Environmental Assessment
MKI Southern Grand Banks Seismic Program, 2014–2018
Addendum

29 May 2014
Project No. SA1250

Environmental Assessment of MKI Southern Grand Banks Seismic Program, 2014–2018 Addendum

Figure 1. Transportation Routes Relevant to White Rose.

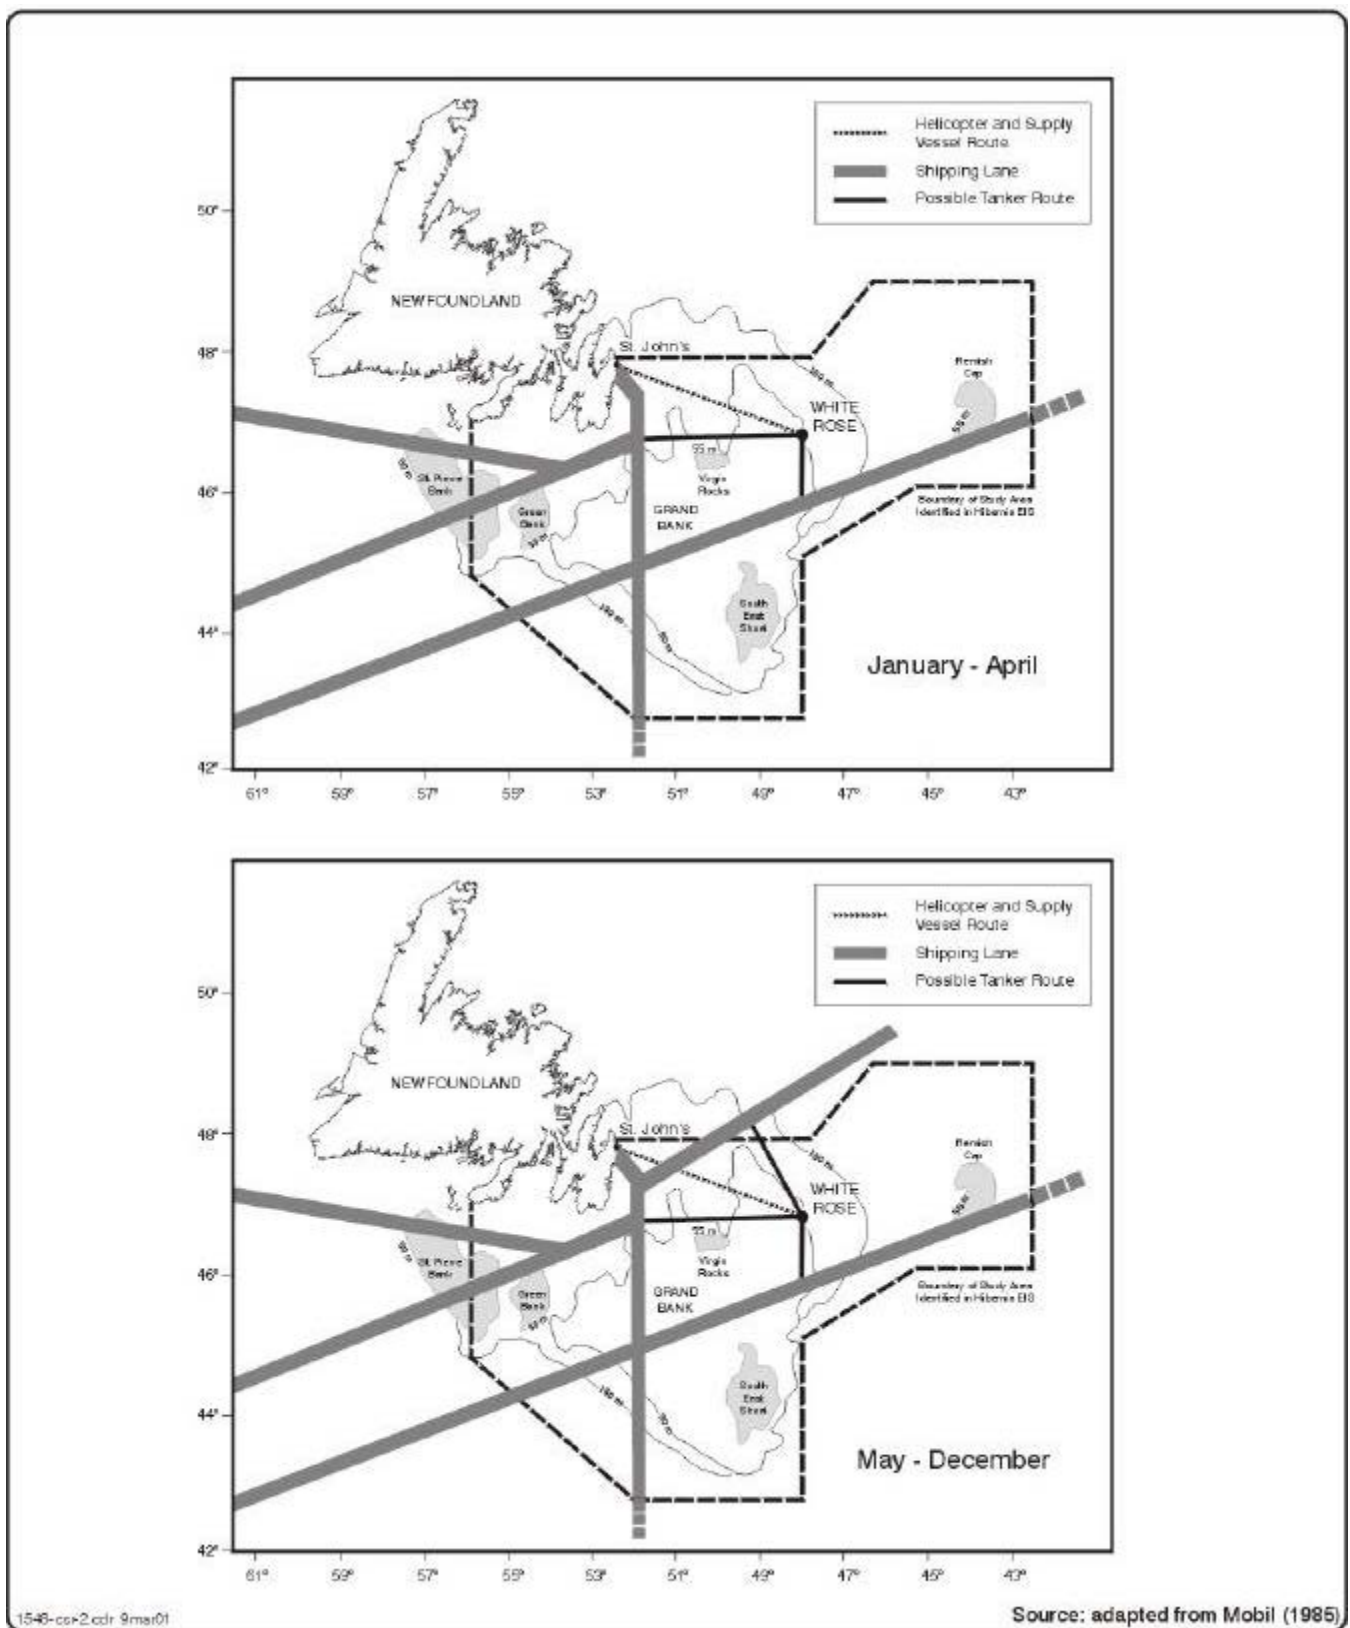
Figure 5.4 Page 218 - it would be appear to have been pertinent to include the shipping lanes for Terra Nova and White Rose petroleum production also.

Response: Figure 5.4, p.218, was obtained from the Sydney Basin Offshore Area SEA (JW 2007). The Proponent was unable to obtain track data for shipping lanes for the Terra Nova and White Rose petroleum production facilities, however it is assumed that vessels follow the most direct route possible (given sea and ice conditions) between the production sites and St. John’s Harbour. The following figures were produced by Husky (Oil) for the *White Rose Oilfield: Comprehensive Study Report* (see Figure 2.2 in Husky 2001) and by Petro-Canada for the *Development Application: Terra Nova Development Environmental Impact Statement* (see Figure 5.5-1 in Petro-Canada 1996) to represent helicopter and supply vessel routes for the White Rose platform and Terra Nova FPSO, respectively:
